Re: Contract No. 200-2004-03805, Task Order 1: Transmittal of Draft Addendum to SCA-TR-TASK1-0003, *Status Report on the Resolution of the Savannah River Site Issues Resolution Matrix*

*Status Report on the Resolution of the Savannah River Site Issues Resolution Matrix*

**Addendum to SCA-TR-TASK1-0003**

**Figure 4-1. Trends in SRS and Hanford Collective Neutron Dose Normalized to Plutonium Production**

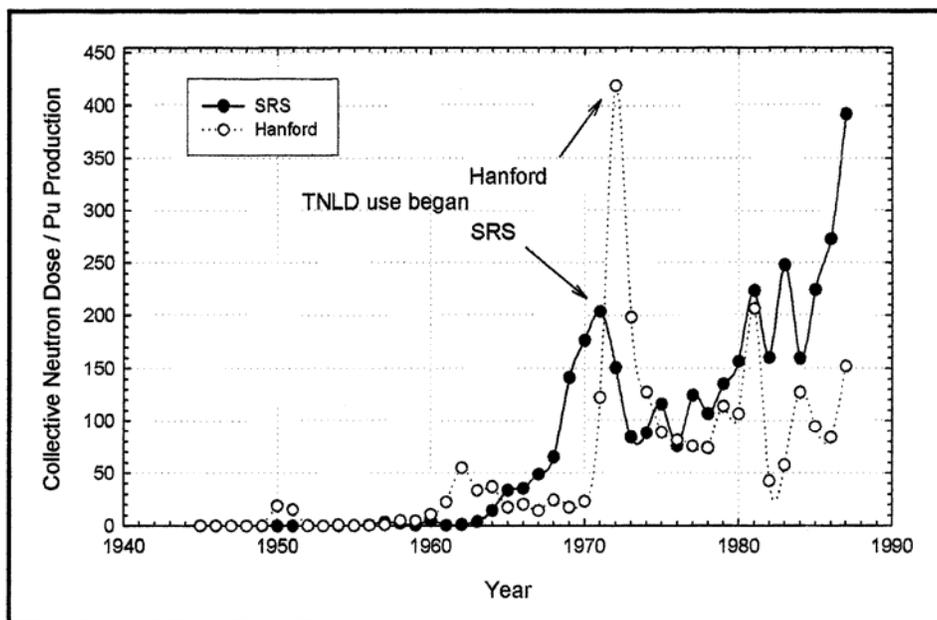
Figure 5.3.4.2-2 referenced above is reproduced below as Figure 4.1. Data shown in Figure 4.1 do not support either statement emphasized in the quotation above:

- At both SRS and Hanford, the rise in collective dose (supposedly standardized to plutonium production) began well before the advent of the TLND; and, in both cases, the standardized collective dose dropped precipitously after the implementation of the TLND with subsequent fluctuations.
- Because the collective neutron doses were standardized (i.e., defined in person-rem per unit quantity of plutonium), the observed oscillations clearly indicate that the collective dose is not correlated with or linked to plutonium production but may very well be the result of variations in neutron fields that surround work conditions in a given area and the variable response of the TLND.

**Figure 4-2. Pu-239 and Np-237 Bioassay Comparison between Data in the Monthly Reports and Data Used for the High-Five Approach**

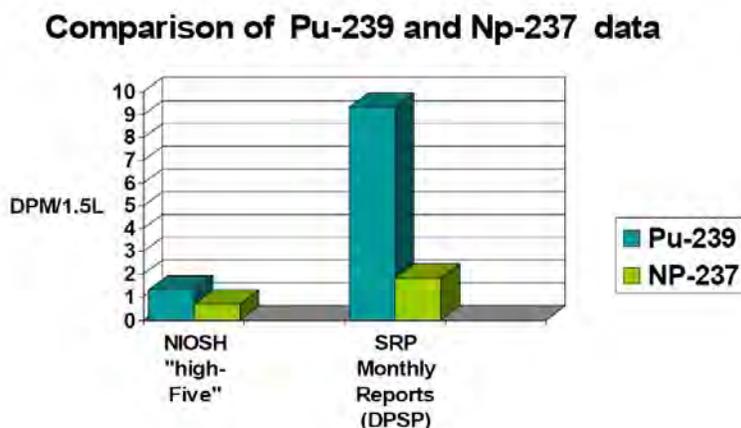
The above examples are only a fraction of the data identified from the DPSP monthly progress reports. Figure 4-2 depicts a synopsis of the bioassay data in the monthly reports versus those from individuals included in the high-five analysis for Pu-239 and Np-237. The monthly reports generally provide bioassay information up through 1965 that is higher than that observed for individuals represented in the high-five analysis. The monthly progress reports accessible to SC&A were available only through 1965 for this analysis.
